Amendment on 20 June 2025

Uninterruptible Power System Units and Valve-regulated Sealed Type Lead Acid Batteries

ID:DD23-17

Amended-Original Requirements Comparison Table
(Uninterruptible Power System Units and Valve-regulated Sealed Type Lead Acid Batteries)

Amended	Remarks
<p style="text-align: center;"><u>Fig. 1 Double conversion topology UPS unit</u></p>  <hr/> <p style="text-align: center;"><u>Fig. 2 Line interactive topology UPS unit</u></p> 	<p>Figs. 1 to 3: Incorporating the figures of UR E21(Rev.2).</p>

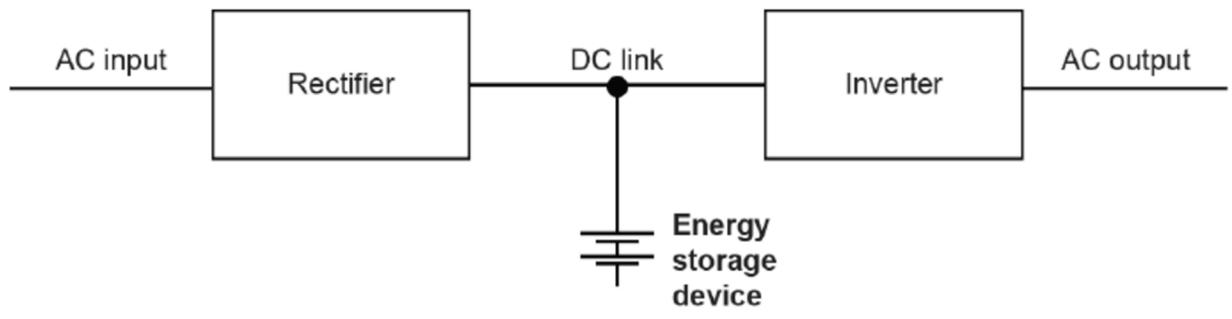
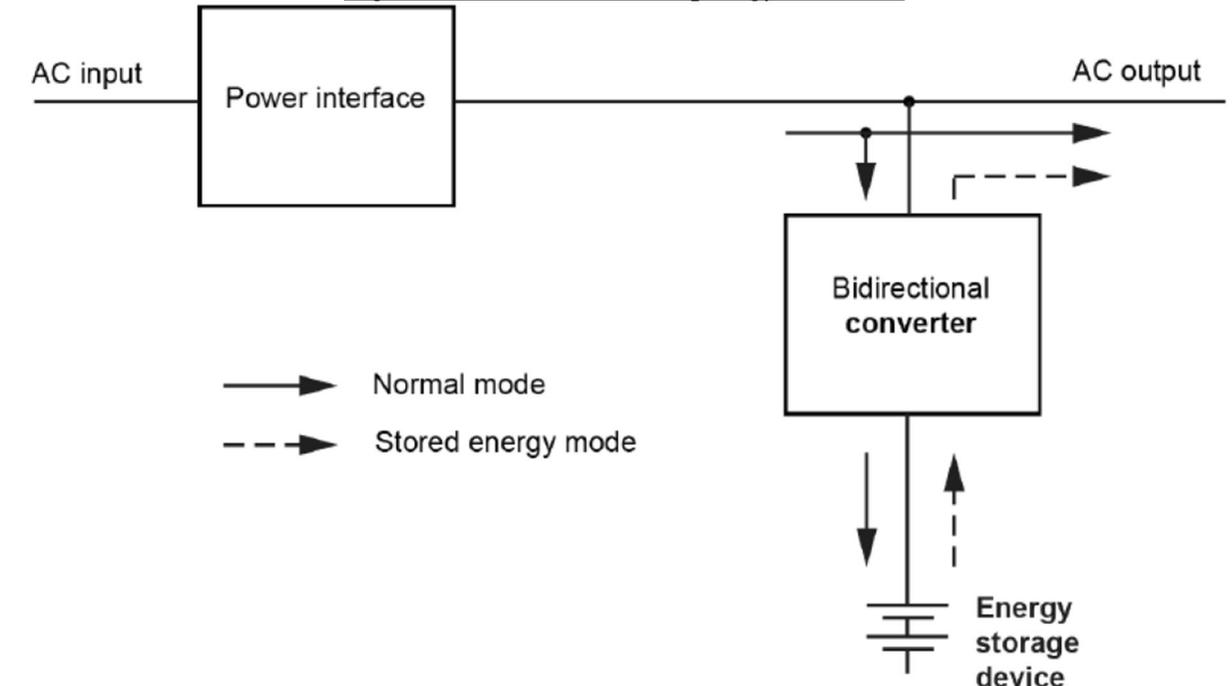
Amended	Original	Remarks
<p align="center">Annex 3.3.3(3) UNINTERRUPTIBLE POWER SYSTEM UNITS</p> <p>1.1 General</p> <p>1.1.1 Application This annex <u>applies when</u> uninterruptible power system (hereinafter referred to as “UPS”) units, as defined in <i>IEC 62040-3:2021</i> as bellow, is installed. Any batteries and semiconductor converters combined with UPS units are to be in accordance with those requirements specified in 2.11 and 2.12, Part H as practicable.</p> <p>(1) <u>When installing UPS units as a continuous and uninterruptible power supply to prevent power failure of “those service necessary to provide normal operation conditions of propulsion and safety” as specified in 3.2.1-2, Part H.</u></p> <p>(2) <u>When installing UPS units as a power supply specified in from 29.2.2-2 to 29.2.2-4, Part R.</u></p> <p>(3) <u>When installing UPS units as an alternative power supply or transitional power supply to the emergency sources of power specified in 3.3, Part H.</u></p> <p>1.1.2 Definitions Definitions of the terms used in this annex are as follows:</p> <p>(1) <u>“UPS units” are</u> sources of electrical power with semiconductor converters, switches and batteries, used for maintaining continuity of loads in cases of</p>	<p align="center">Annex 3.3.3(3) UNINTERRUPTIBLE POWER SYSTEM UNITS</p> <p>1.1 General</p> <p>1.1.1 Application This annex <u>to</u> uninterruptible power system (hereinafter referred to as “UPS”) units, as defined in <i>IEC 62040-3:2011</i>, <u>apply when providing an alternative power supply or transitional power supply to the emergency sources of power specified in 3.3, Part H.</u> Any batteries and semiconductor converters combined with UPS units are to be in accordance with those requirements specified in 2.11 and 2.12, Part H as practicable.</p> <p>(Newly added)</p> <p>(Newly added)</p> <p>(Newly added)</p> <p>1.1.2 Definitions Definitions of the terms used in this annex are as follows:</p> <p>(1) UPS <u>means</u> sources of electrical power with semiconductor converters, switches and batteries, used for maintaining continuity of loads in cases of</p>	<p>Incorporating 1.1 of UR E21(Rev.2).</p> <p>(1) to (7): Incorporating 2 of UR E21(Rev.2).</p>
